# FINAL DRAINAGE REPORT

## ABERT RANCH SUBDIVISION

Rename to  
Preliminary  
Drainage Report.

Add: PCD File No.: SP-17-007

## Routed Hydrograph Results

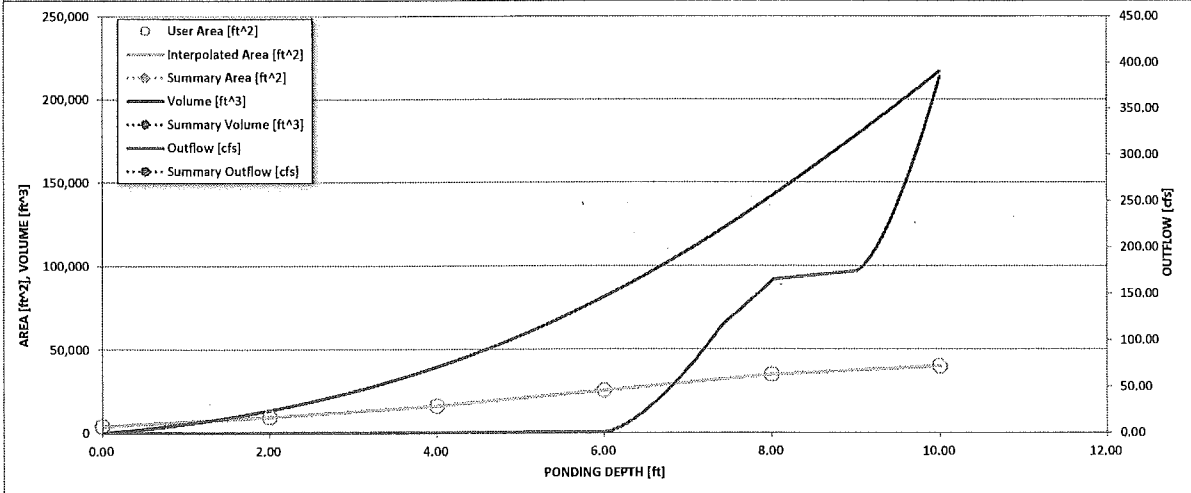
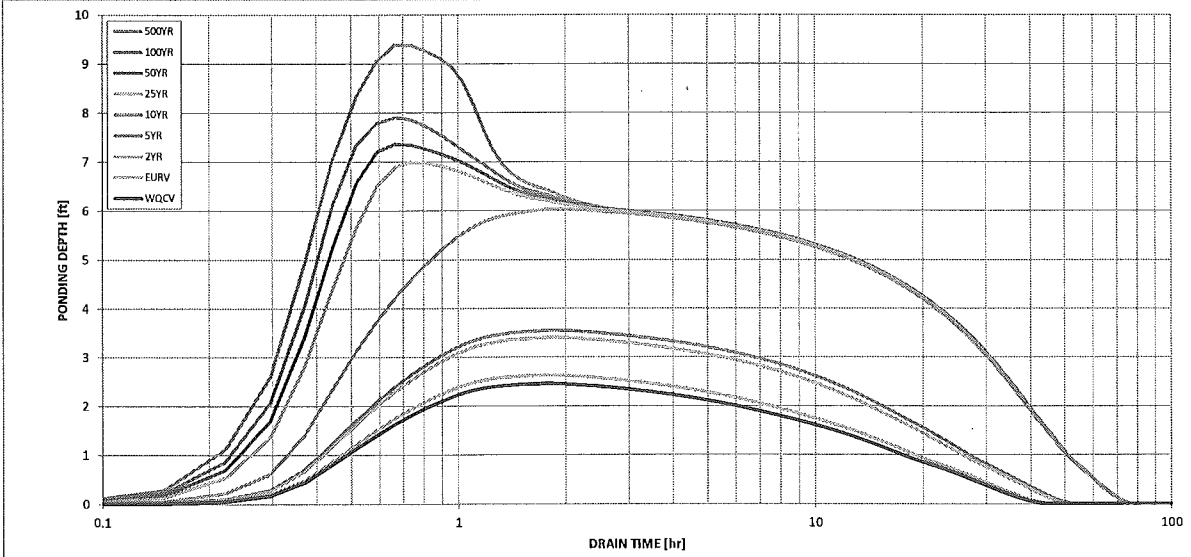
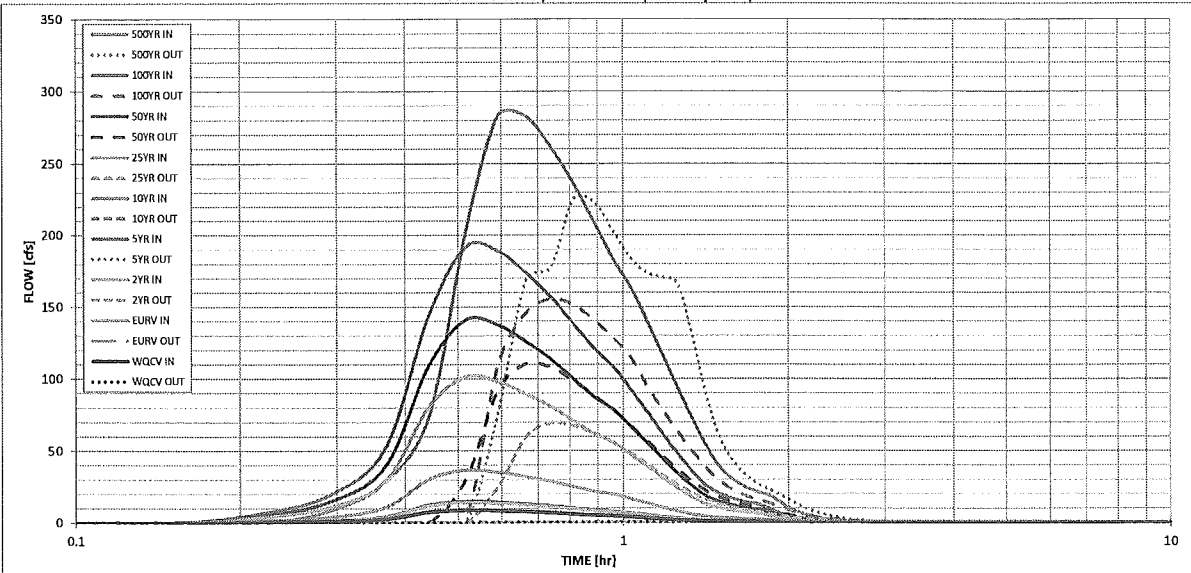
Three different volumes are associated with the design of a full spectrum detention facility: WQCV, EURV, and 100-yr. Revise Zone 2 and 3 in the worksheet

## HISTORIC DRAINAGE PLAN

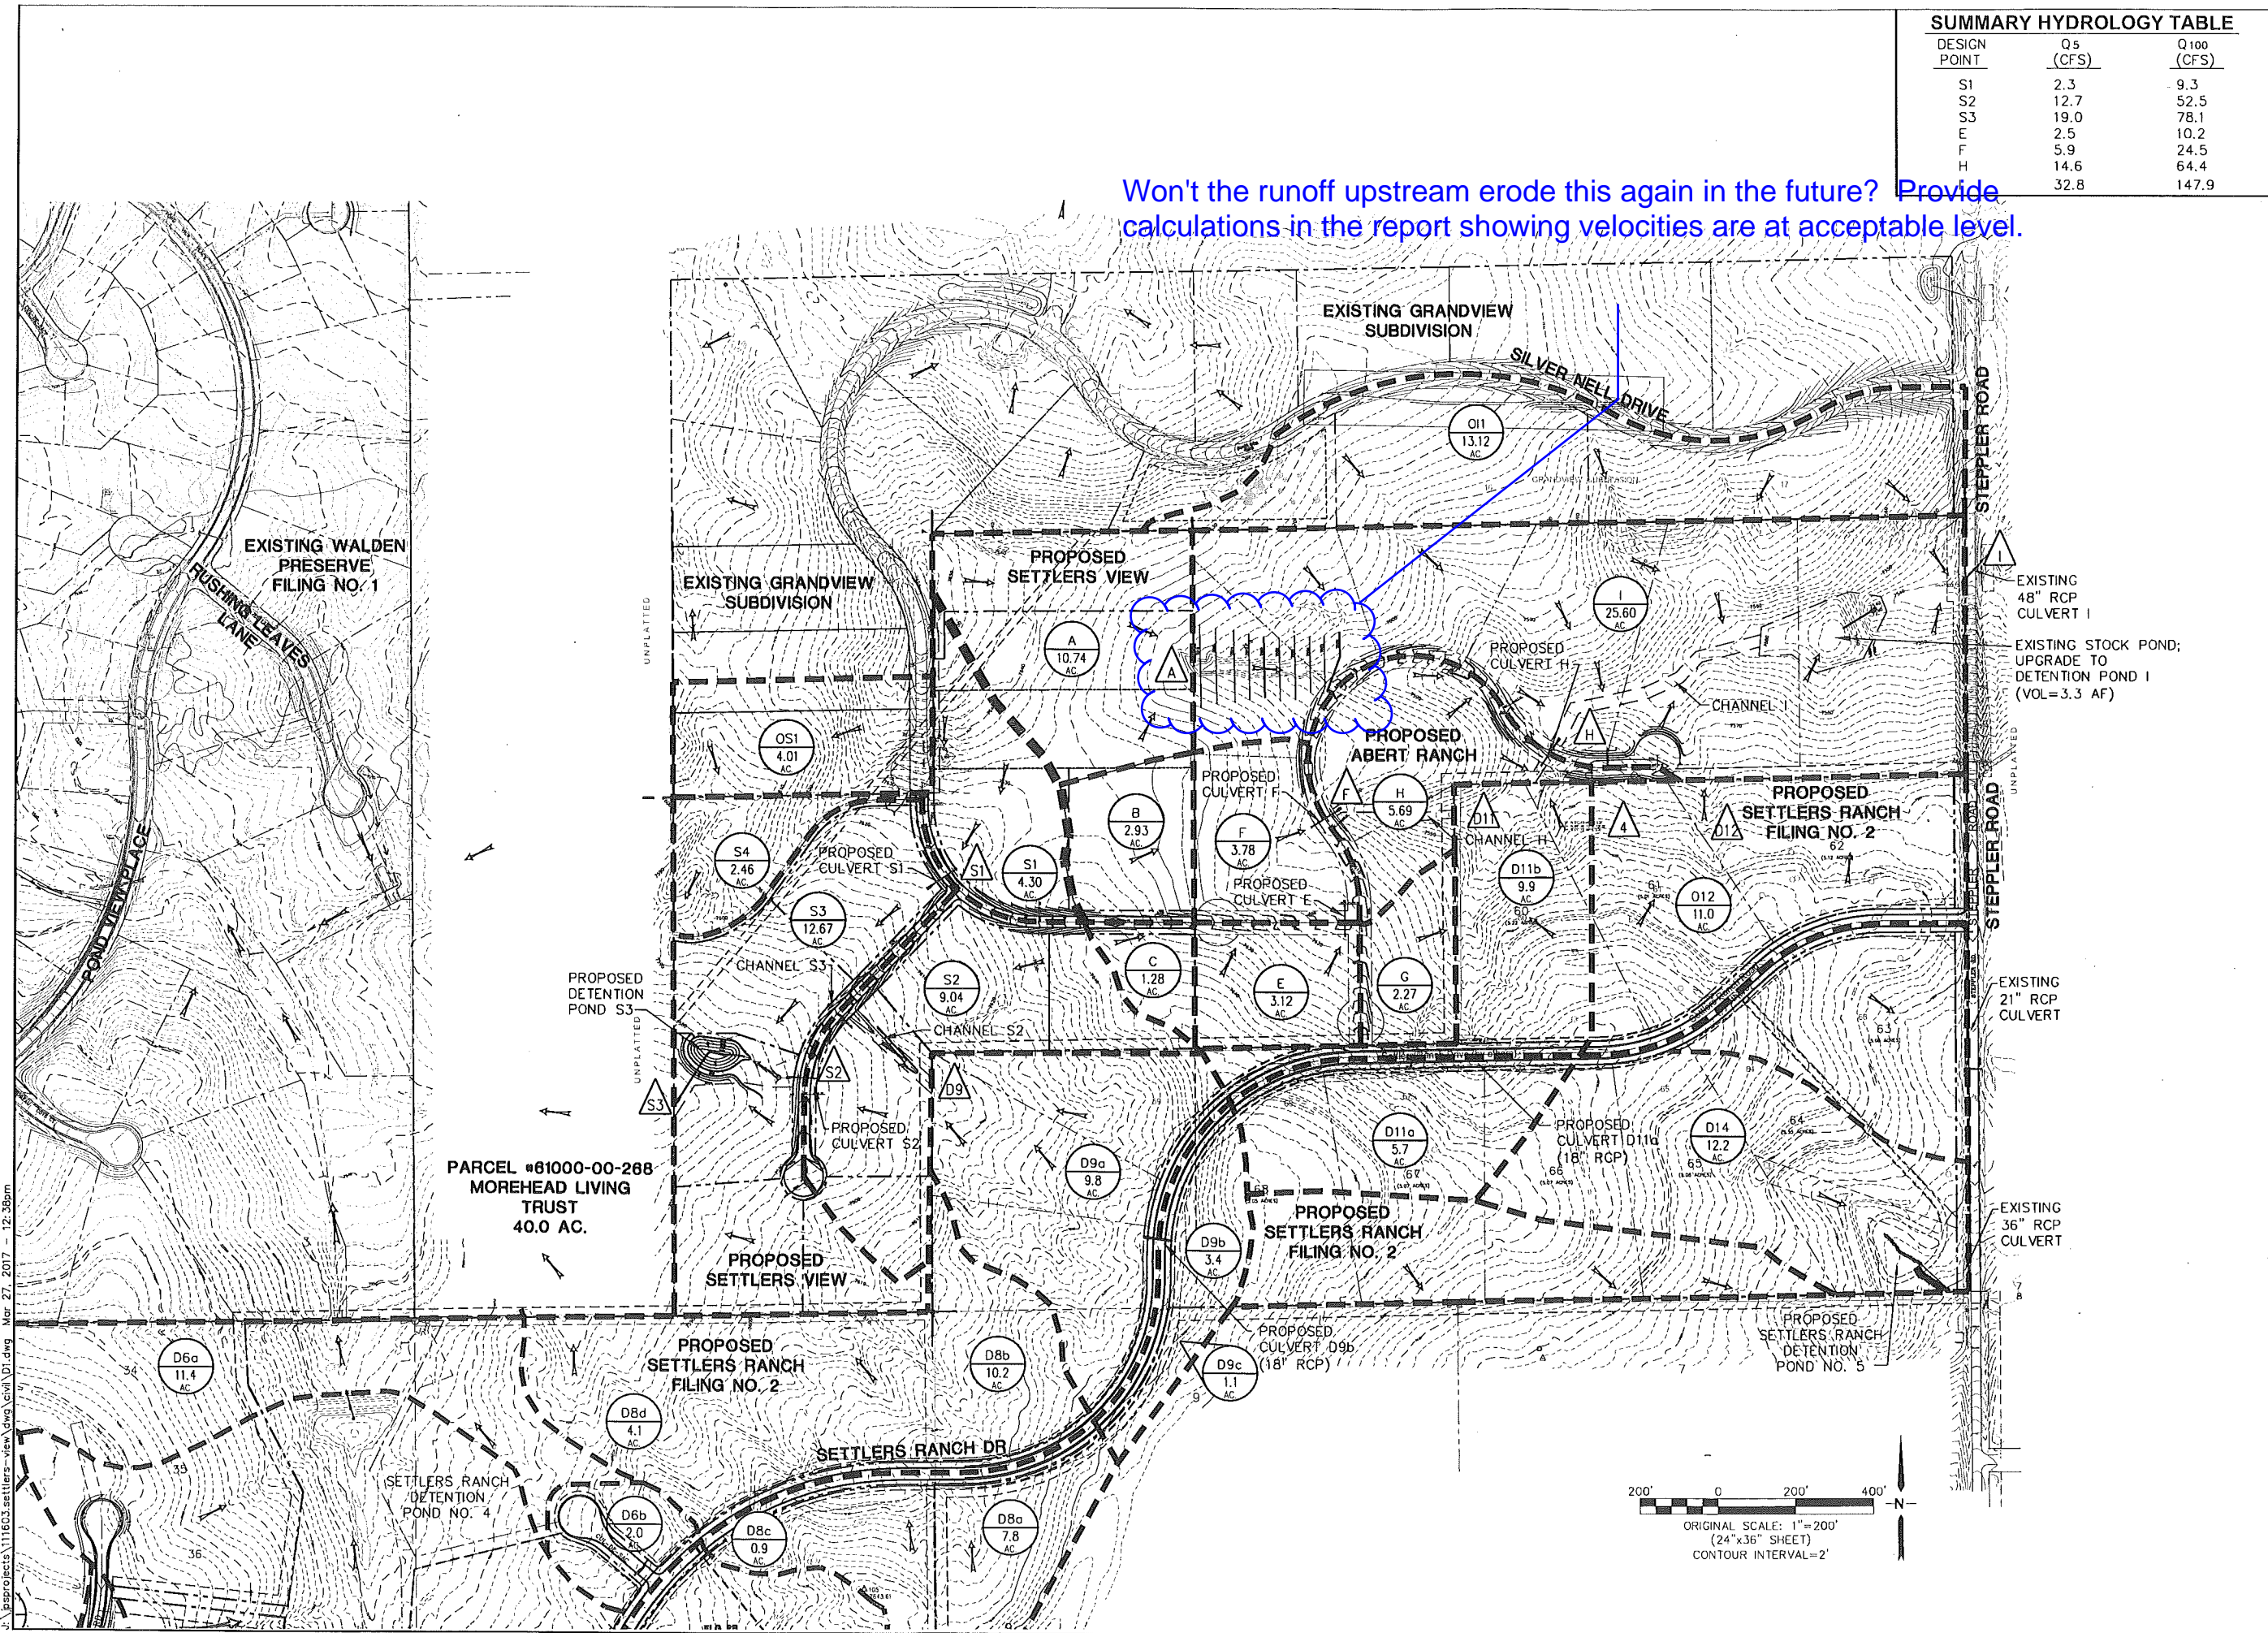
Won't the runoff upstream erode this again in the future? Provide calculations in the report showing velocities are at acceptable level.

**PRELIMINARY GRADING  
& EROSION CONTROL PLAN**

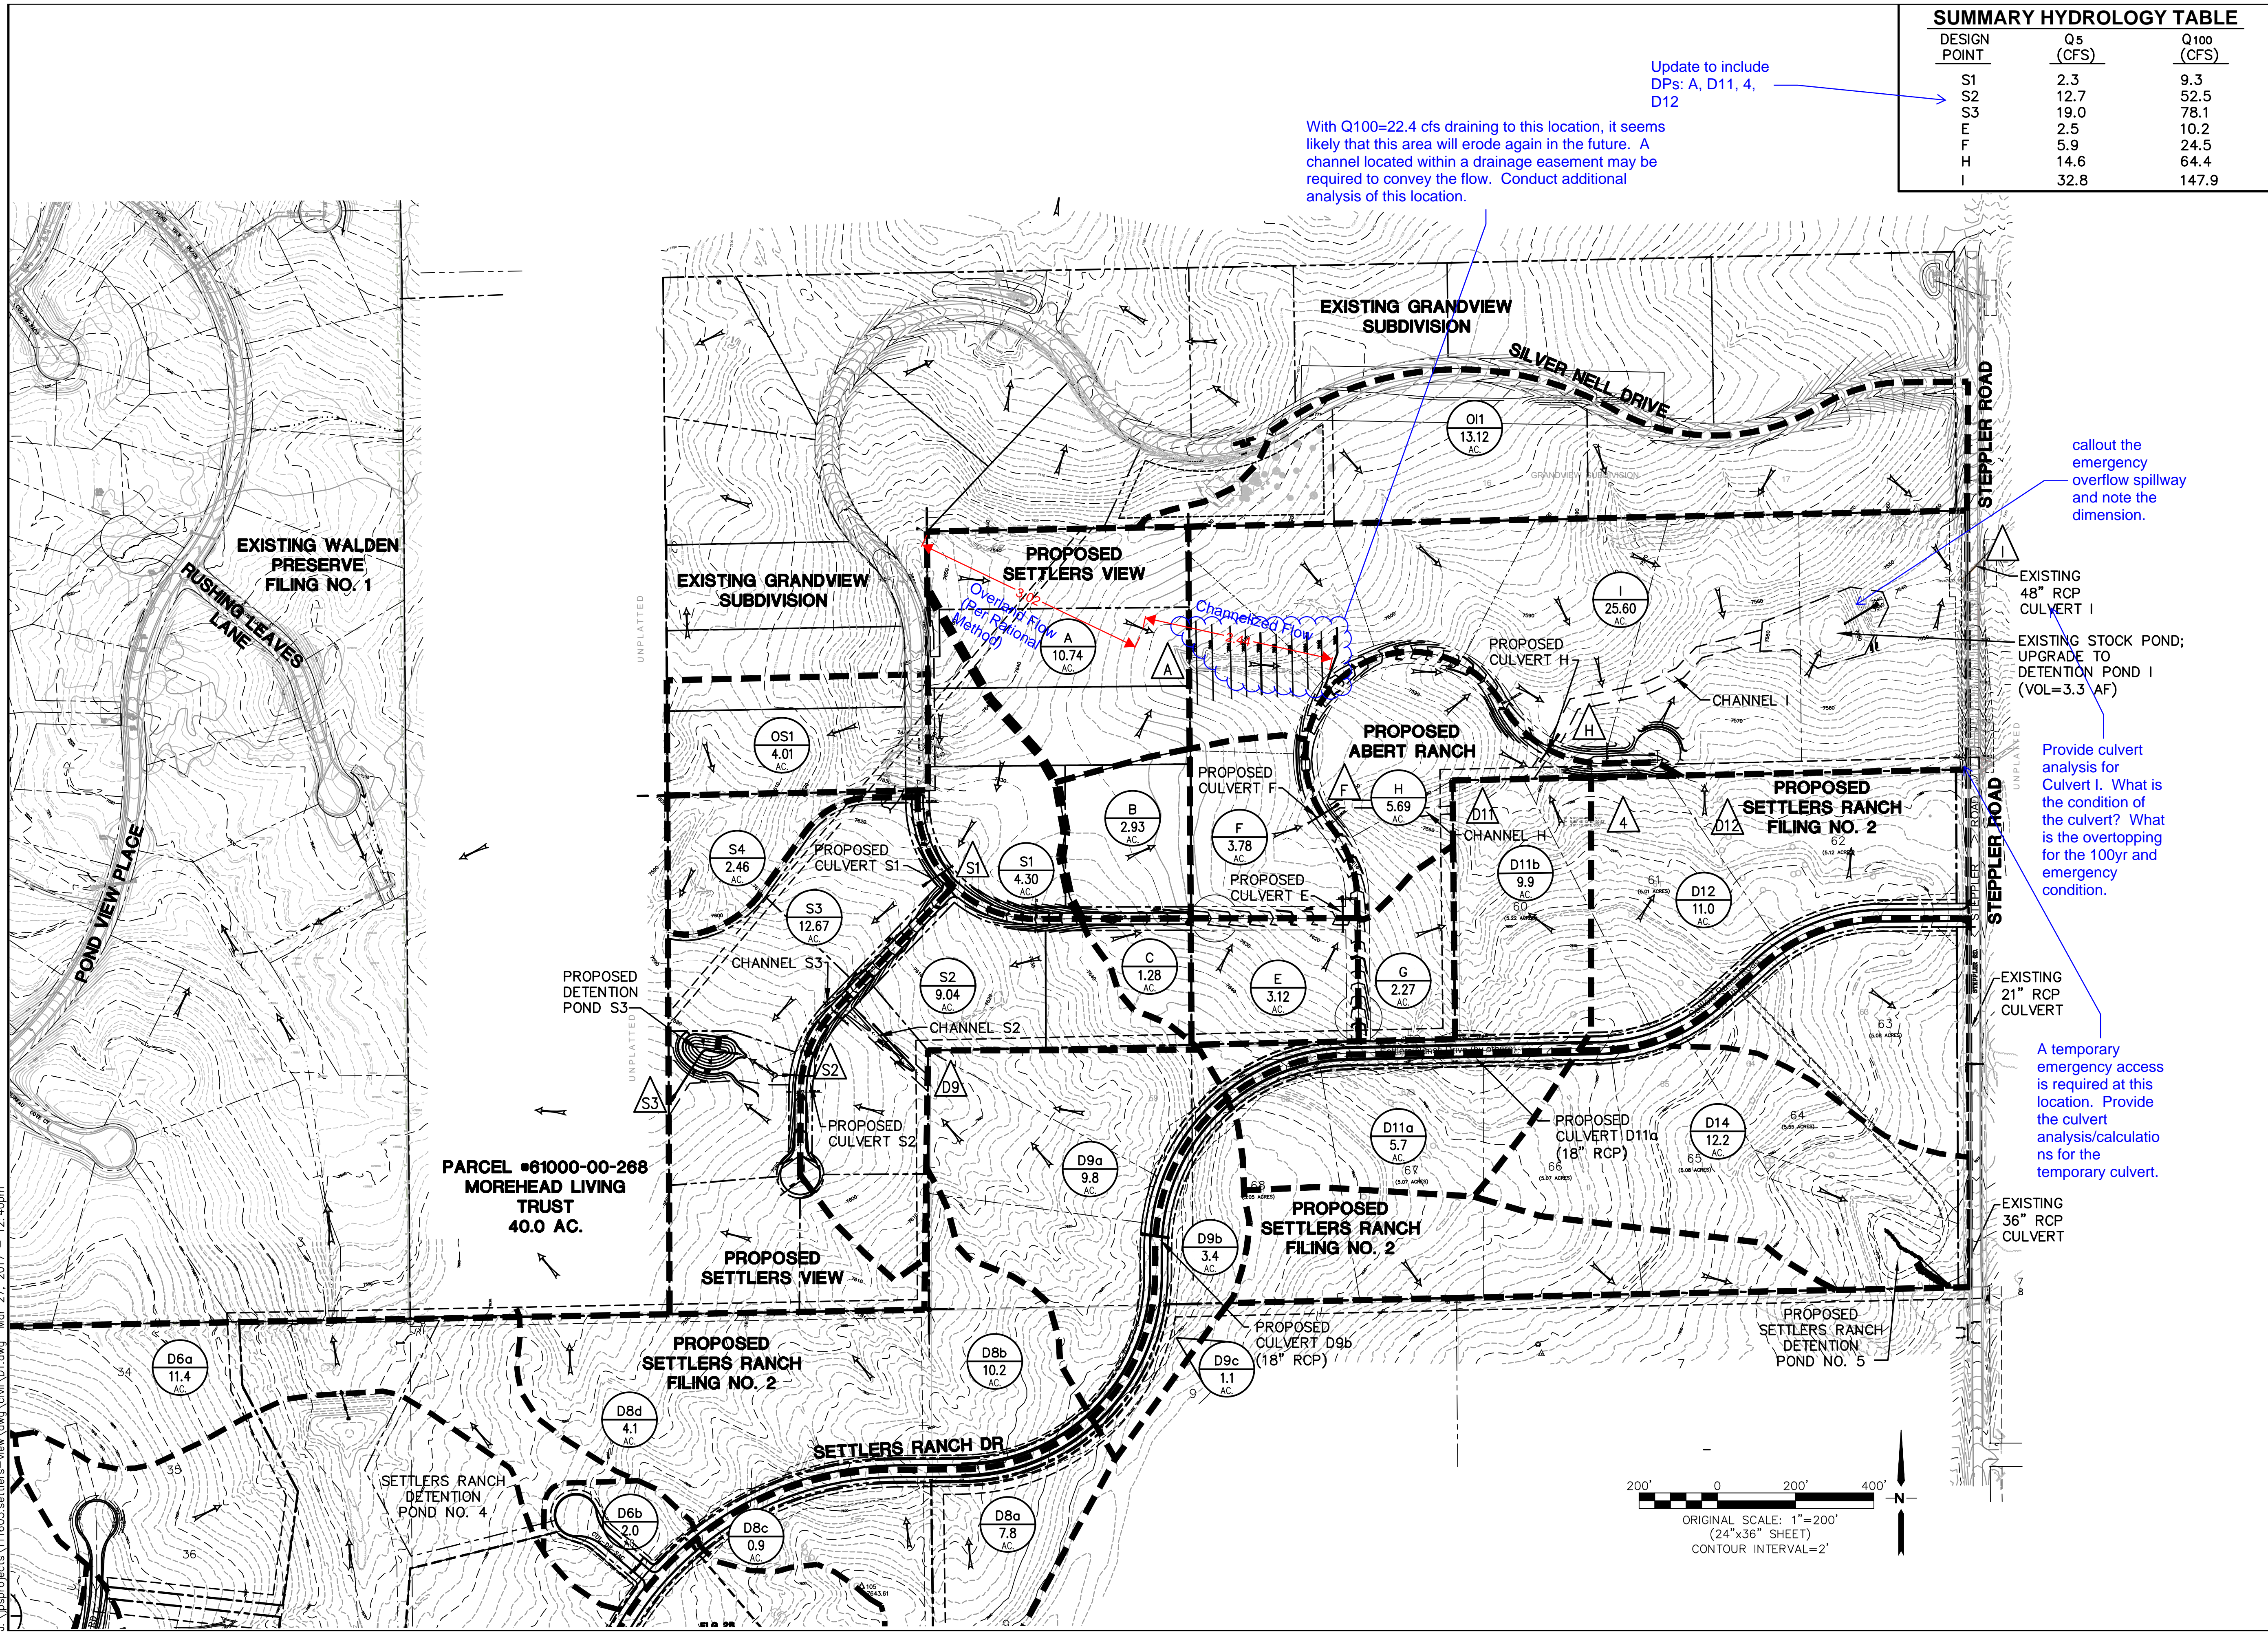
Update to include DPs: A, D11, 4, D12

With Q100=22.4 cfs draining to this location, it seems likely that this area will erode again in the future. A channel located within a drainage easement may be required to convey the flow. Conduct additional analysis of this location.

Provide culvert analysis for Culvert I. What is the condition of the culvert? What is the overtopping for the 100yr and emergency condition.

A temporary emergency access is required at this location. Provide the culvert analysis/calculations for the temporary culvert.
